6. Proposed Changes

Amendments are proposed to the approved development to facilitate permanent power infrastructure via an Energex substation. This change is necessitated following consultation with Energex who required a substation for the site in lieu of a pad mount transformer (PMT). As a result, the proposed amendments generally comprise the following:

Figure 3: B99 Swept path access and egress adjoining new substation (Source: PTT)

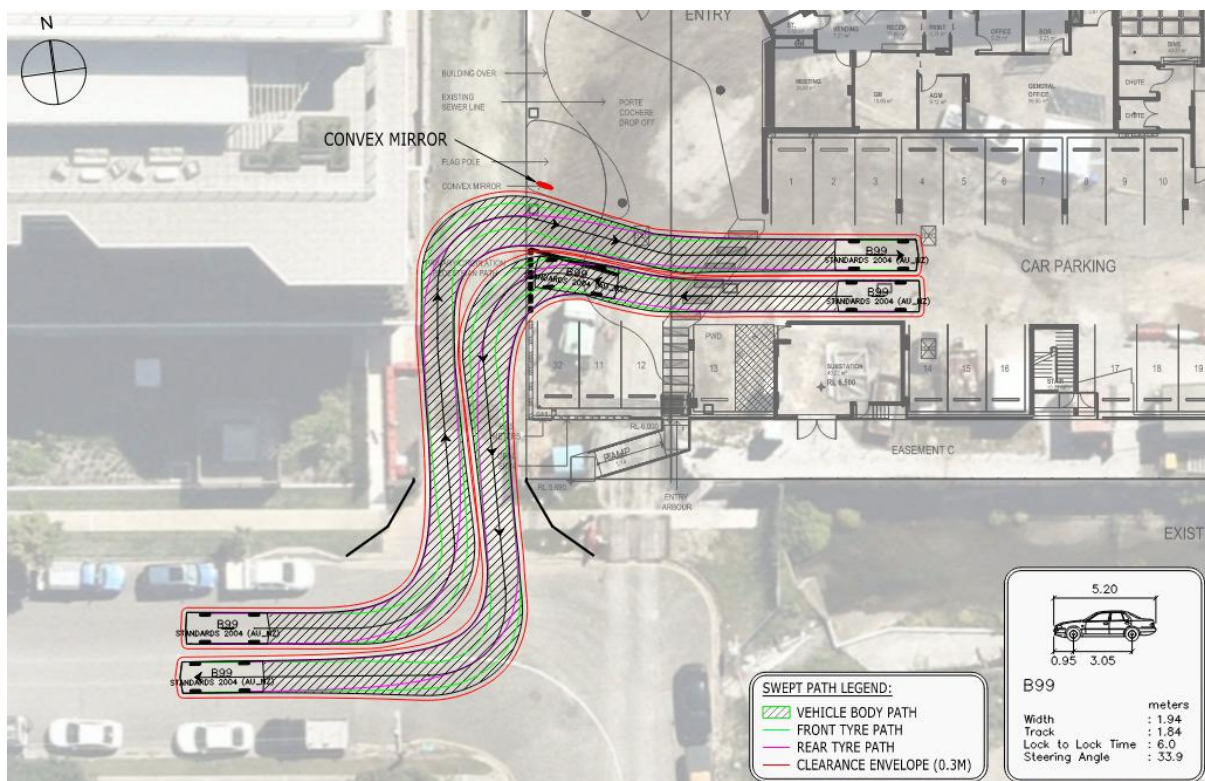
A swept path assessment completed by PTT demonstrates that the revised layout can accommodate the manoeuvring requirements of passenger vehicles, service vehicles and refuse collection vehicles without adversely impacting the operation of the development (refer Figure 3). Furthermore, the relocation of the previously approved PMT from the south-west corner of the site improves sight distances between vehicles entering and exiting the ground floor car park relative to the approved arrangement. Whilst sight lines remain partially constrained by the stepped wall, gas meter enclosure and vehicles parked within space 32, a convex mirror will be installed adjacent to the internal driveway intersection to further improve visibility and reduce the potential for vehicle conflicts, in accordance with the traffic engineering recommendations.

Figure 4: Proposed Landscaping Plan – Ground Floor (Detailed Plan 2) (Source: Arcadia)

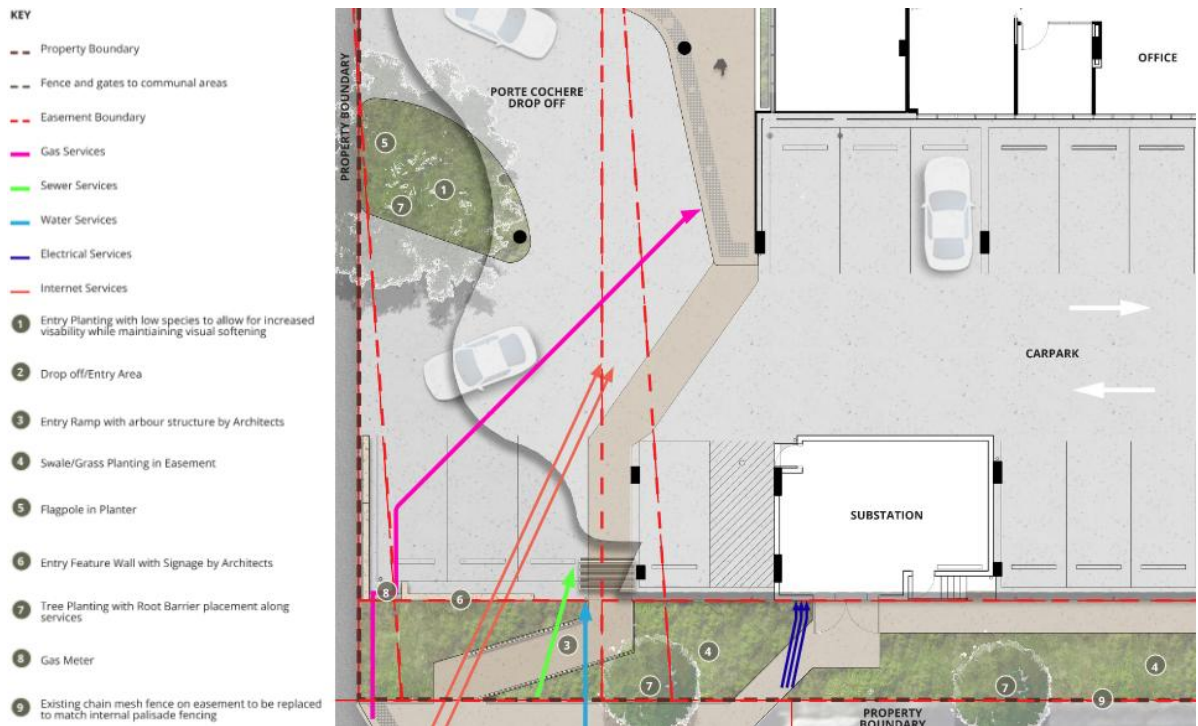
To further enhance the streetscape presentation of the development, additional landscaping is proposed adjacent to the revised car parking arrangement and substation interface. In response to the prelodgement meeting held with Council, the inclusion of a large canopy tree was explored however the south-west corner of the site is heavily constrained by existing and proposed service infrastructure as illustrated in

Figure 4. Accordingly, the proposal incorporates garden bed planting and soft landscaping treatments to improve visual amenity and soften the built form at this corner of the site.
